**Technical Memorandum
Review of Draft Environmental Impact Report for the Village at Squaw Valley
Specific Plan**

July 13, 2015

Prepared for Sierra Watch
Prepared by: Tom Myers PhD
Hydrologic Consultant, Reno NV

Figure 1: Monthly full-development, 2040, demand for the Village at Squaw Valley. The total is 234 af.

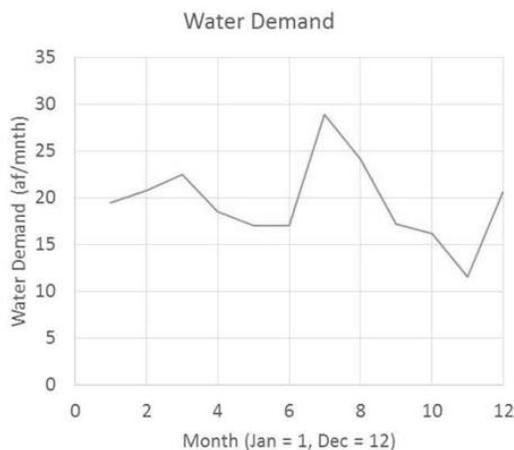
A potential large source of error in the demand is the occupancy rate, which I discuss in greater detail in the review of the Water Supply Assessment in Attachment 2. Occupancy could be up to 80% higher than the estimated rate because the WSA assumes annual occupancy is 55.2% based on observed rates from 2009 through 2011, a significant recession period. Full occupancy would be 80% higher than the recession-era occupancy, therefore the water supply sufficiency estimates should be based on much higher potential demand even if the underlying estimates are accepted as accurate. Actual occupancy will likely be temporally variable, therefore the water supply sufficiency analysis, and analysis of environmental impacts for the DEIR, should consider future demand in a variable fashion. This means that the simulation of future demands should consider periods with occupancy much closer to full.

Another issue regarding demand is seasonal timing, as in which seasons the demand is higher and lower. The projections in the WSA rely on past distributions and on the monthly occupancy rates from 2009 through 2011 (Hunt and van Dyne 2014). The projected demand peaks in July and August (Figure 1), which during most years is after recharge has decreased and ceased. The primary issue is that more of the future demand will occur during a period of the year when less water is available. Climate change, which will decrease recharge during late summer, will exacerbate this issue. .
